SUBJECT: Bulletin "C" Dated May 7, 2020
PROJECT #: A1310-00
DESCRIPTION: Restoration Upgrades to Exterior Building Envelope
State Office Building - 135 Hanover Street
Trenton, Mercer County, NJ

PROJECT#: A1310-00 Restoration Upgrades to Exterior Building Envelope
State Office Building
135 West Hanover Street,
Trenton, Mercer County, N.J.

BULLETIN “C”

Sheet No.
A103

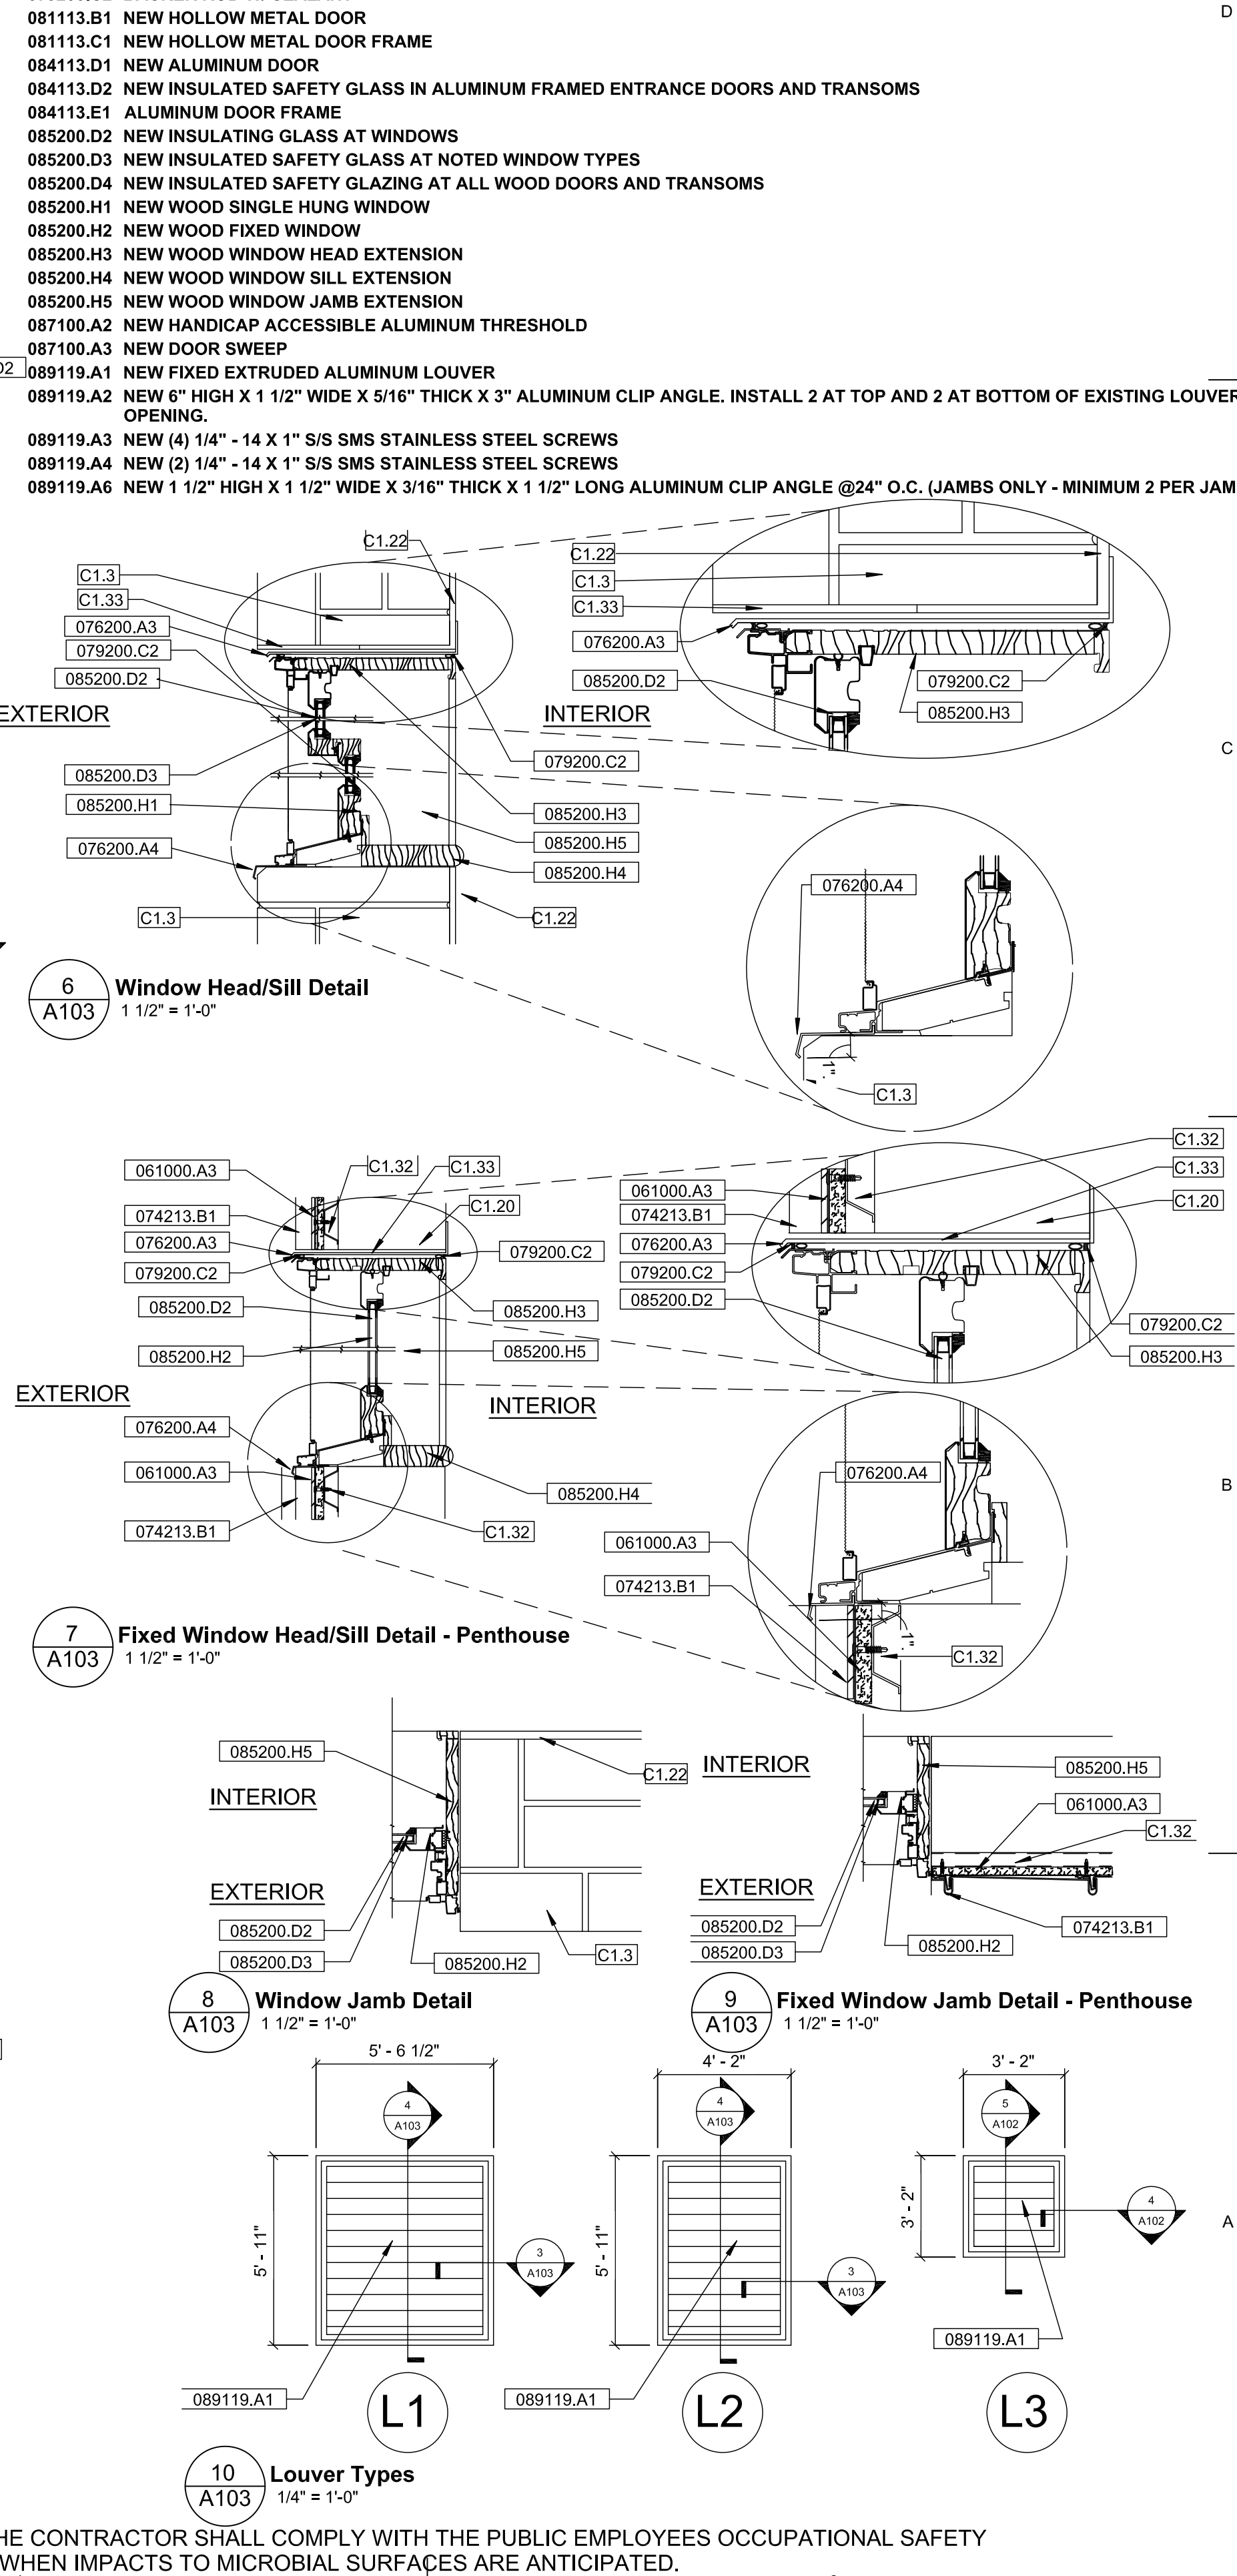
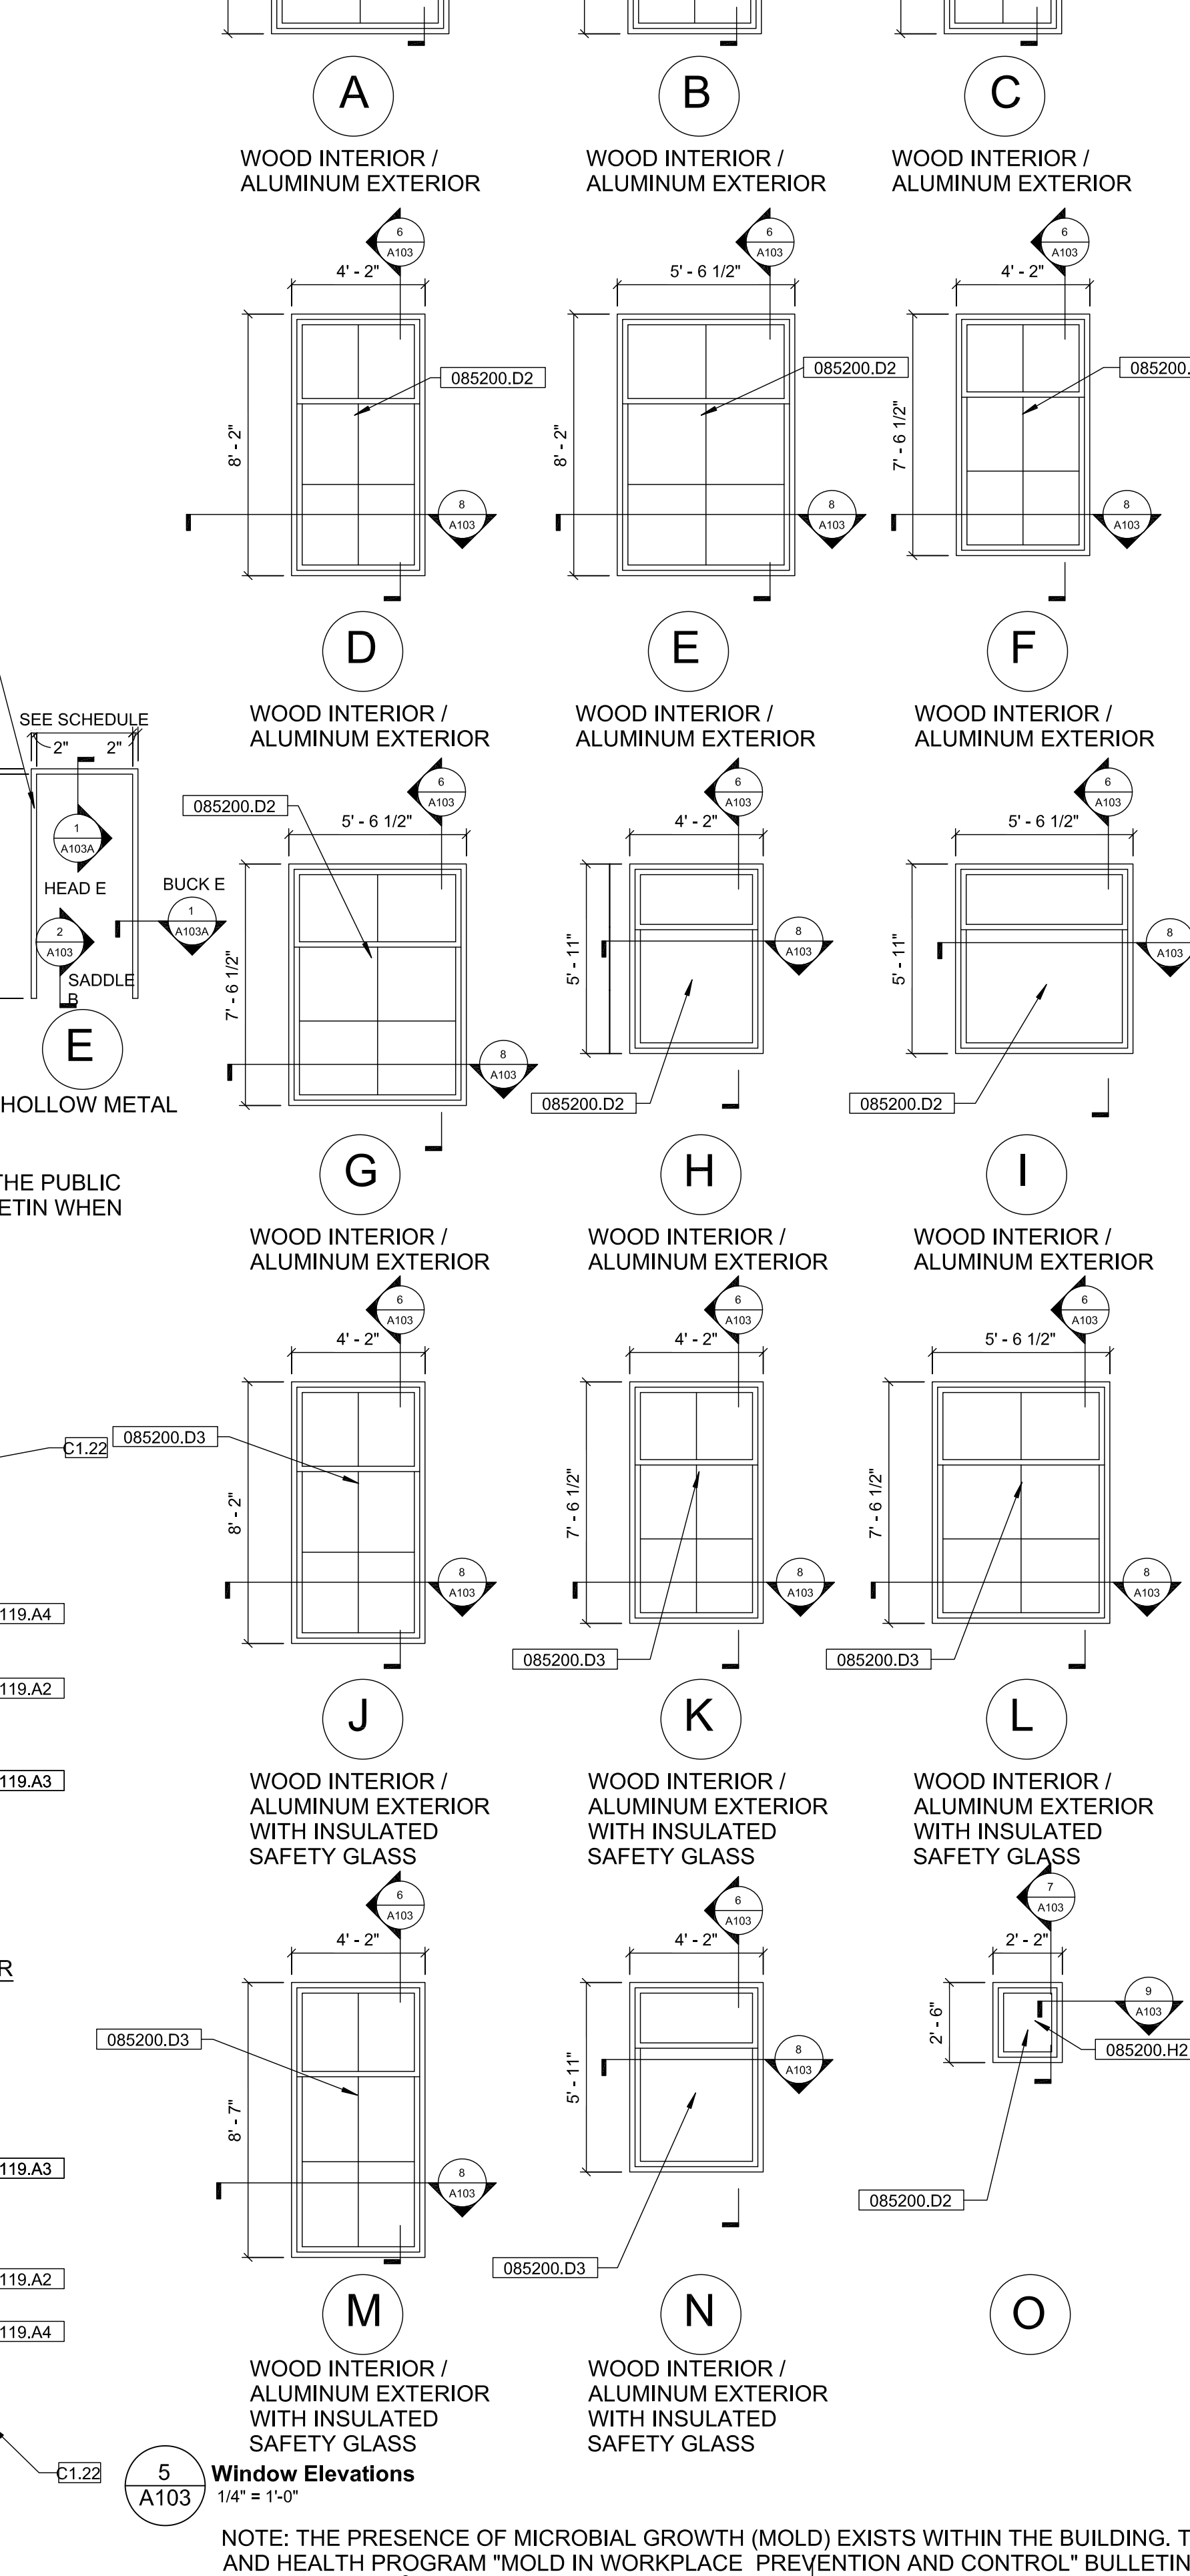
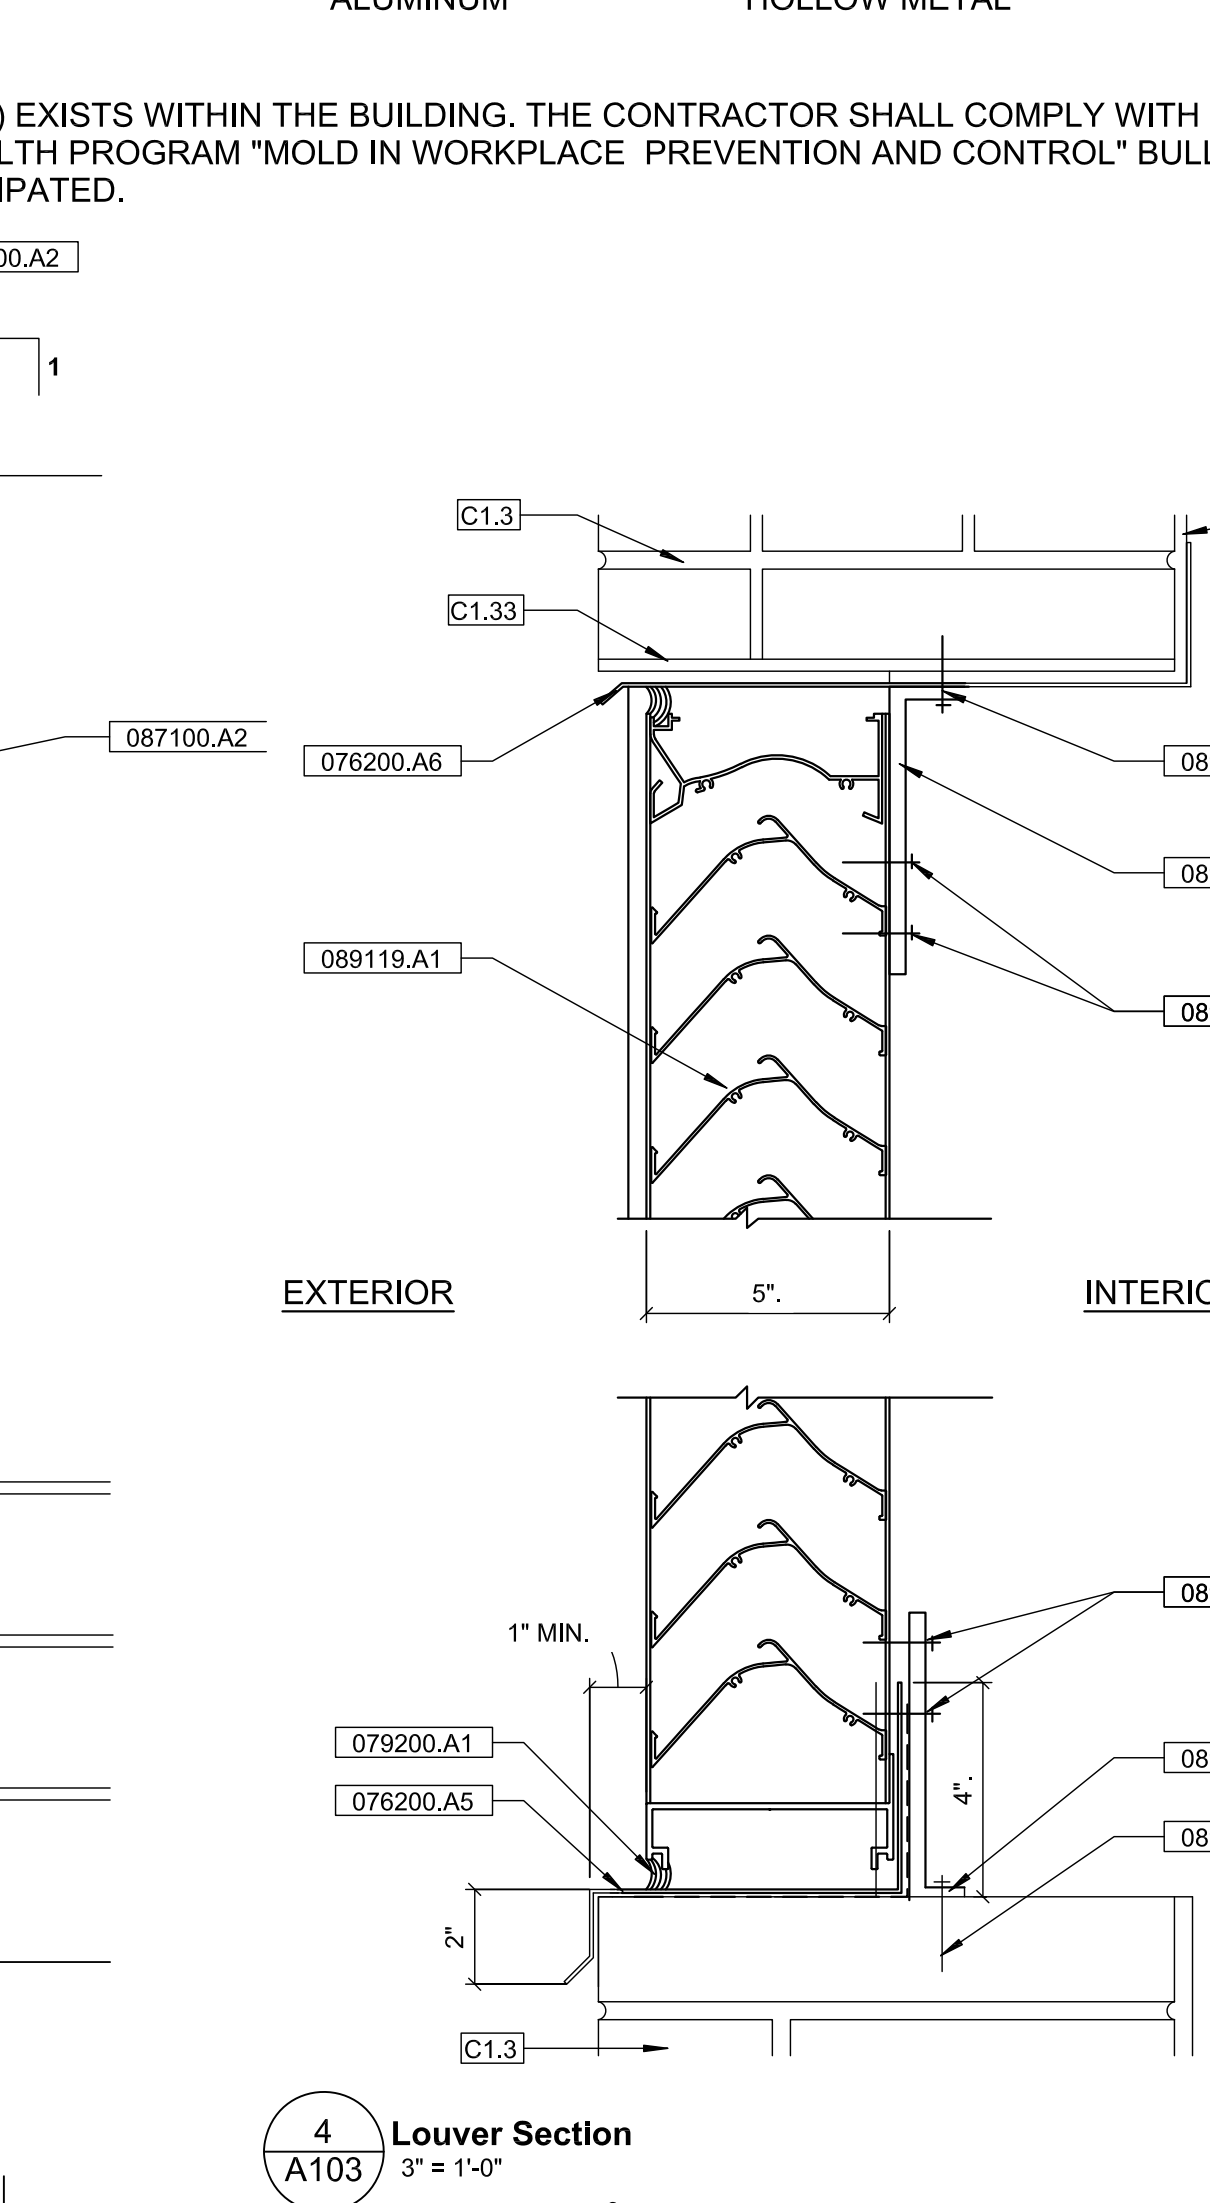
1. Are Marvin Windows an acceptable manufacturer for the replacement windows?
RESPONSE: Marvin Windows is an acceptable manufacturer for the new windows. See attached “Revised Drawing A103”, “Revised Drawing A200”, “Revised Drawing A201” and “Revised Specification Section 085250” for more information.
2. Is there any underground plumbing work required?

10. It appears that the interior side of the windows is pre-finished by the manufacturer—Are the header, jamb and sill extensions per detail 6/A103 pre-finished too or do they get painted on site

7. Section 085250, page 4, paragraph H specifies “3 ½” profiled brickmould casing with 2 1/8” projected sill nosing with end caps and frame expanders.” The window details on the window schedule on Sheet A103

shows head and sill flashing with metal wall panels. These details do not show any casing or subsill (sill nosing). The elevations also do not show any casing or subsill. Is Marvin clad casing and subsill required on this building?

14. On the window types on Drawing A-103, there is a window Type 'C' shown. On the floor plans and elevations no window type 'C' is called out

RESPONSE: The header, jamb and sill extensions should be prefinished.

RESPONSE: All penthouse windows will not have the profiled brickmould casing and projected sill. Only the windows where brick is present will have the profiled brickmould and the projected sill nosing.

RESPONSE: Delete all reference to Window Type 'C' from the drawings and specification. See attached "Revised Drawing A103".
